SLG47525/28 Errata Note

This document contains the known errata for SLG47525/28 and the recommended workarounds.

Figure 1

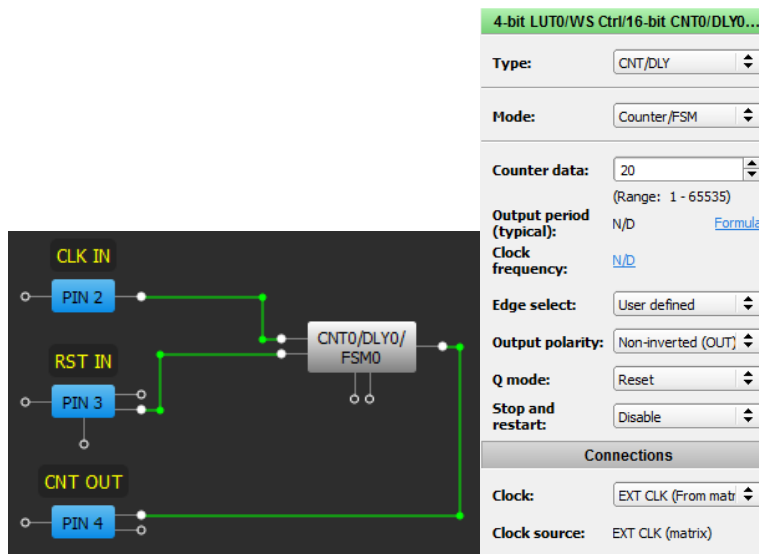
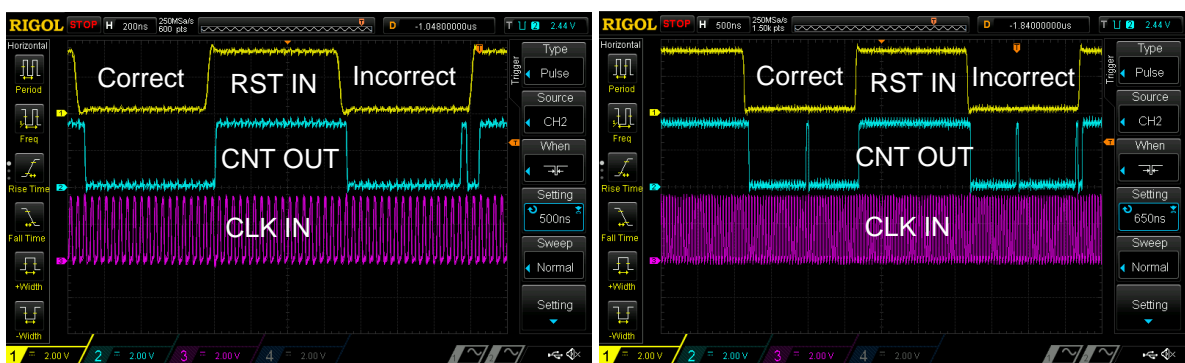
If the Counter Reset is asserted at the same time as a rising clock edge, it is possible that the Counter Data will be reset incorrectly and the counter output may appear faster than expected. This phenomenon appears more often as the clock frequency increases.

Synchronize RESET input of the Counter with its CLK using 2 DFF cells as shown on Figure 3.

Figure 4

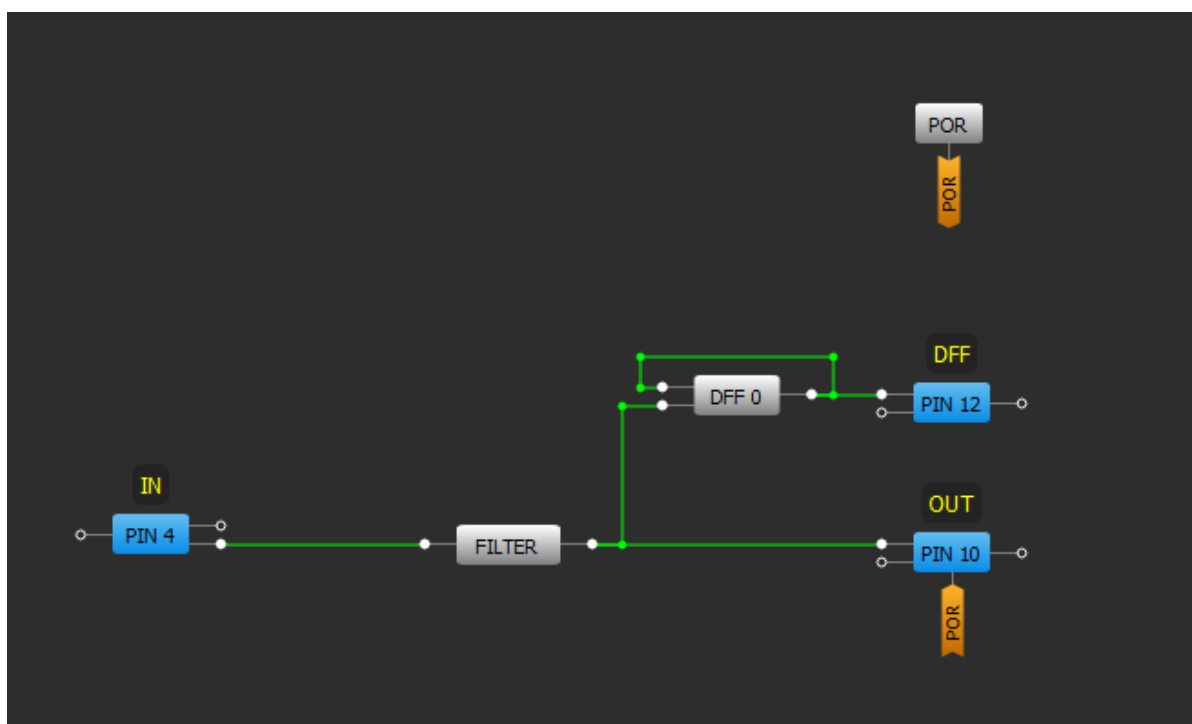
If clock type high frequency input comes in, the FILTER cell may not filter it out. There are several factors like input frequency, duty cycle, and LOW duration in such signal that may lead to its passing through FILTER block.

Currently there is no workaround for this issue. Filter block is good at filtering short spontaneous glitches. It is intended to be used in series connection before the delay cell to avoid its latching.

Figure 8

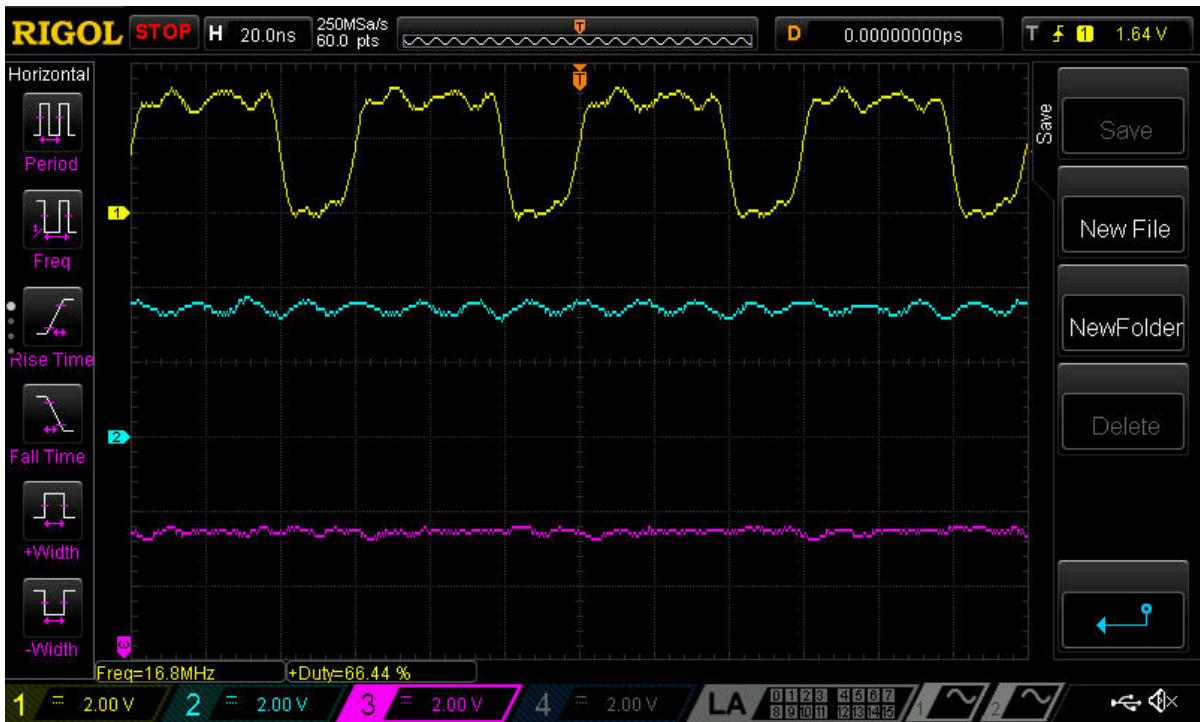
- Period is 60 ns. Pulse width is 40 ns, DC = 66.67 % (correct functionality).

Figure 9

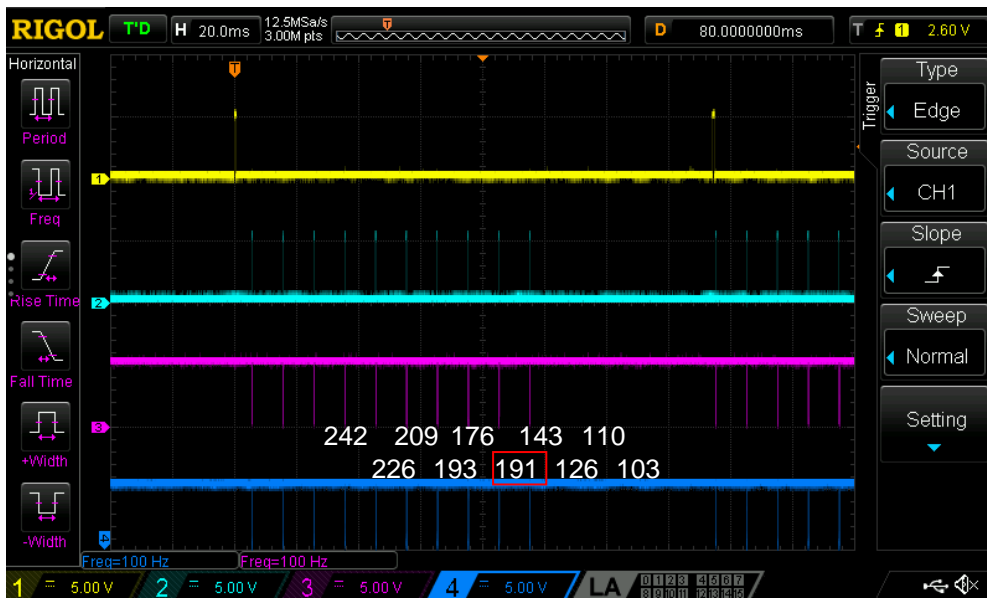
Asynchronous interaction between the CNT/DLY clock input and the I²C LATCH signal (generated by an I²C read command of the CNT/DLY block's count value) can result in an incorrect I²C data read. The CNT/DLY block will count accurately, but the count value transferred into the block's I²C read register might be loaded incompletely if the I²C LATCH signal and the clock input occur at about the same time.

The example data capture in Figure 9 shows ten periodic I²C reads of CNT2/DLY2 configured to count down at about 16 clocks per read. The sixth read sample erroneously shows a value greater than that of the fifth. The seventh sample reads as if the previous I²C error never occurred - the difference from the fifth sample (176) to the seventh (143) is 33 clocks or 16 clocks + 17 clocks as expected.

If the possibility of incorrect I²C data reads cannot be accommodated for by external software checks, one can guarantee proper operation by stopping the CNT/DLY block's clock during I²C reads through one of the following methods: by disabling the oscillator block, by reconfiguring the CNT/DLY block's clock source, or by gating an external clock using a LUT (Look Up Table) in the signal matrix. After disabling the CNT/DLY block's clock, the count registers can be read without error. Please note that this workaround will add the I²C read and processing time to the counter's overall clock period.

Figure 10. I²C Write of 16-Bit Counter Data Example

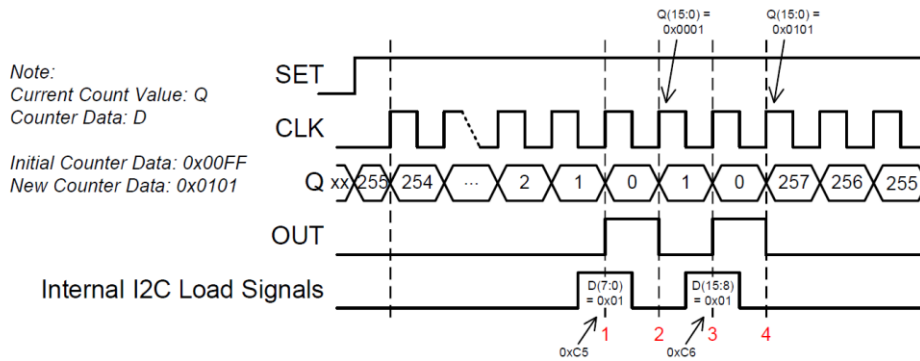
The timing diagram in [Figure 10](#) sets up a case where an improper output will be seen on the counter. In this example, the initial Counter Data value (D) is set up as 0x00FF. As you can see, the Current Count Value (Q) decrements from 255 down to 0 with rising edges on CLK. At time "1" denoted by a red number 1, an I²C command (not shown) has just been sent to the GreenPAK device to reconfigure the Counter Data value to 0x0101.

As previously mentioned, the 16-bit value is loaded from the I²C buffers to the Counter Data registers in 8-bit chunks. Right at time “1”, the LSB byte (0x01) is loaded into the Counter Data registers. This makes the Counter Data value temporarily equal to 0x0001. At time “2” between the internal I²C load signals, the counter receives a rising edge on its clock input. This causes the Current Count Value to underflow and to be loaded with the Counter Data value which is 0x0001. At time “3”, the MSB byte (0x01) is loaded into the Counter Data registers setting the Counter Data value to 0x0101. At time “4”, the Current Count Value underflows again and is set to the Counter Data value of 0x0101.

I²C Write of Counter Data: accommodate for the double pulse described in Case 1.

Figure 11. 16-Bit I²C Counter Block Diagram

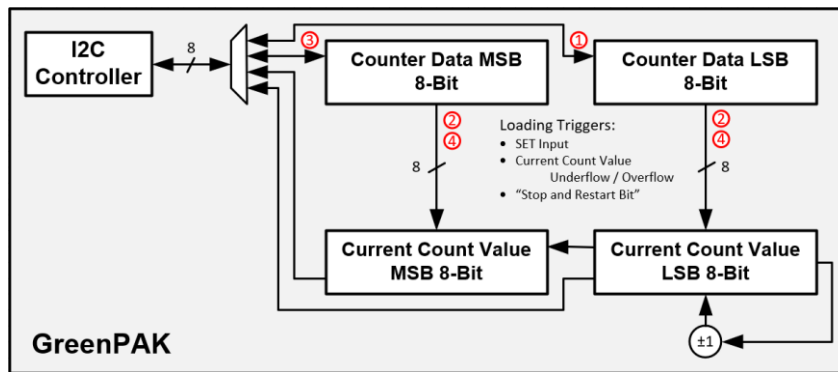
This behavior results in two output pulses on OUT when only one pulse is expected. Observing this behavior depends upon the asynchronous timing between the counter’s clock and an I²C write command to the Counter Data registers. For some applications, the extra pulse on OUT can be ignored and the counter will self-correct after underflowing, overflowing, or being SET/RESET through the GreenPAK connection matrix.

Figure 12. Counter Behavior

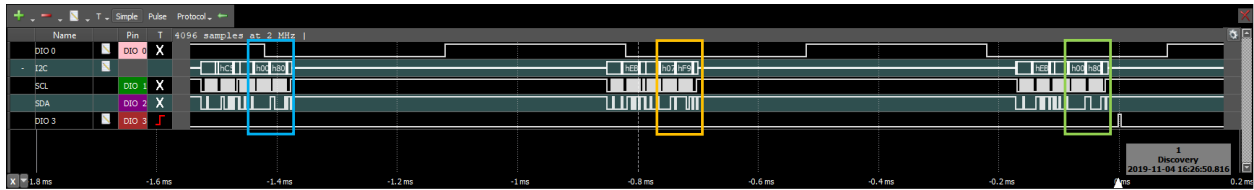
For the following condition, the Counter Data register contents are unexpectedly loaded into the counter’s DFF chain. This behavior occurs when there is a falling edge on the counter block’s clock input during the data return

portion of the I²C read of the Counter Data registers. Figure 12 shows this falling edge boxed in light blue followed by two I²C reads of the Current Count Value registers.

As you can see by the MCU data log below, the Current Count Value gradually increases from 0xF904 to 0xF907 but is unexpectedly reset to 0x8000. Please note that the colored HEX values in the MCU Log correspond to the boxed I²C read commands shown in the waveform above. As previously described, this reset occurs because there is a falling edge on the counter’s clock input while the GreenPAK device is responding to the I²C read request to 0xC5 and 0xC6 (note that 0xC5/0xC6 are the Counter Data registers and 0xEB/0xEC are the Current Count Value registers for CNT0).

I²C Read of Counter Data: avoid reading Counter Data via I²C while the counter is being clocked.

Within the MCU, we recommend saving the Counter Data register configuration as a software variable so that the Counter Data register does not need to be read during counter operation.

Figure 13

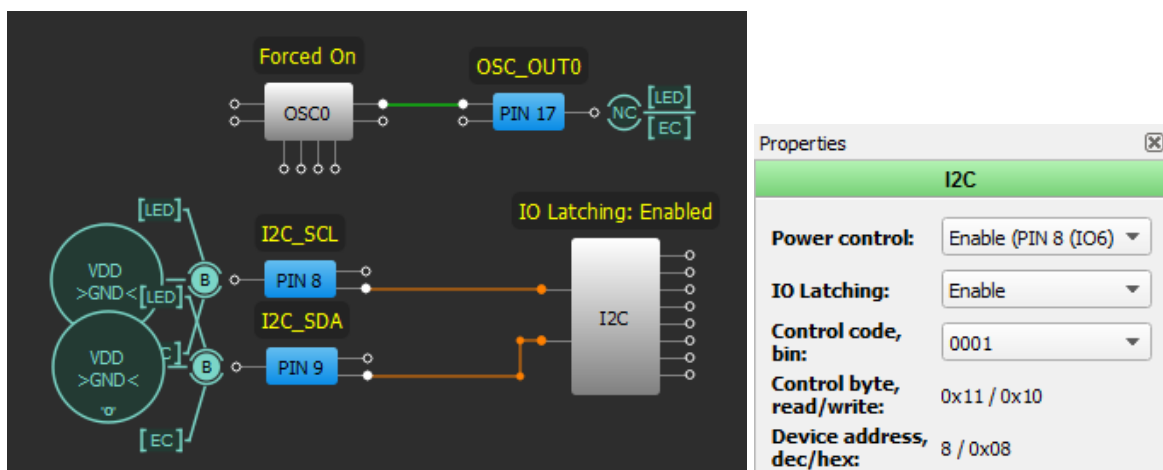
The GreenPAK device does not check for a matching I²C Slave address condition before triggering ‘IO Latching’. A Start bit on the I²C bus will trigger IO Latching. A Start bit is when I2C_SDA goes low first followed by I2C_SCL going low after.

In the example in [Figure 13](#), we will be monitoring the OSC output, which is measured by a scope on Channel 3 via PIN17 (“OSC_OUT0”). The I²C bus will be forced low to create a START bit.

Disable IO Latching in programmed OTP. This register is I²C-write locked during normal operation and therefore should be disabled in configuration file.

Do not share I²C bus with other devices and make sure the I²C bus is not powered down while the GreenPAK is still powered through V_{DD}.
